APPENDIX D: AGENCY COMMENTS ON RESPONSE TO SUBMISSIONS

Springvale Mine Extension Project - Response to Submissions

Springvale Colliery Extension Project Modification 1 (SSD 5594 MOD 1) Comment on the Response to Submissions

Springvale Colliery Extension Project Modification 1 (SSD 5594 MOD 1) Comment on the Response to Submissions Detailed comments – DPI Water

Figure 1. Extracted Figure 2.1 from Jacobs' report

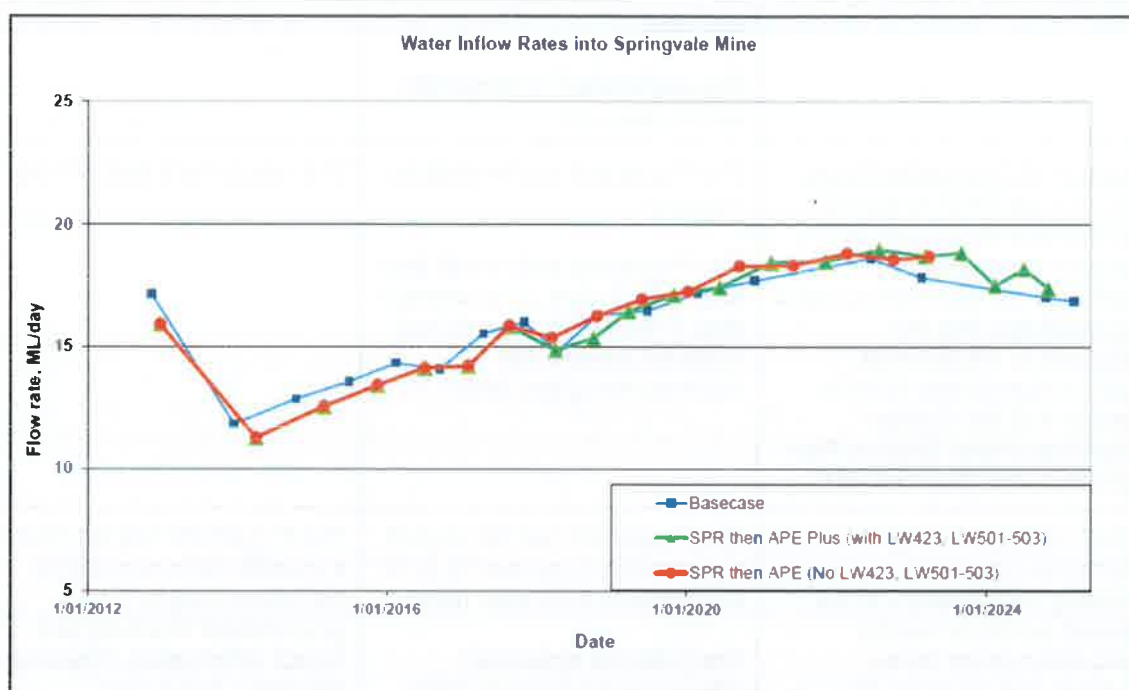
The Proponent has re-run their COSFLOW NGM for the correct mine layout and generated the necessary outputs. The outputted results now properly reflect the approved mine layout, irrespective of any business reason to exclude them (see Appendix C for an enhanced discussion). The previous work was erroneous and poorly explained. The revised outputs are shown in Figure 1 and are very similar to the original. Following this, the Proponent's analysis of the results depicted in Figure 1 is presented.

Key aspects are provided as follows:

- The mine inflow results presented for the 'SPR then APE Plus' simulation, which included all approved long-walls at Springvale Mine under SSD5594, are consistent with the original 'SPR then APE' case (Adhikary and Wilkins, 2015) and the CSIRO (2013) predictions (Adhikary and Wilkins, 2013) which assessed the entire mine footprint. Maximum mine inflows for the three simulations are provided below:
 - The maximum mine inflows for the 'Basecase' (Adhikary and Wilkins, 2013) is 18.6 ML/day in 2022
 - The maximum mine inflows for the 'SPR then APE' case (Adhikary and Wilkins, 2015) is 18.8 ML/day in 2022
 - The maximum mine inflows for the 'SPR then APE Plus' case (Adhikary, 2016) is 19.0 ML/day in 2022.
- The Springvale Mine Extension Project EIS (Section 10.2.3.1) notes the maximum mine inflow for the whole mine plan, the 'Basecase', as approved, as 19 ML/day in Year 2022.

Given the above, the baseflow predictions, with respect to modelled surface water reaches, and modelled mine inflows in the 'SPR then APE Plus' simulation, are consistent with Adhikary and Wilkins (2015) report, and, as presented in Adhikary and Wilkins (2015), are consistent with Adhikary and Wilkins (2013). The impacts and environmental consequences for the proposed modification area are therefore expected to be consistent, as discussed in the SEE, with the impacts presented in the SVMEP EIS and approved in SSD5594.

DPI Water accepts this analysis.
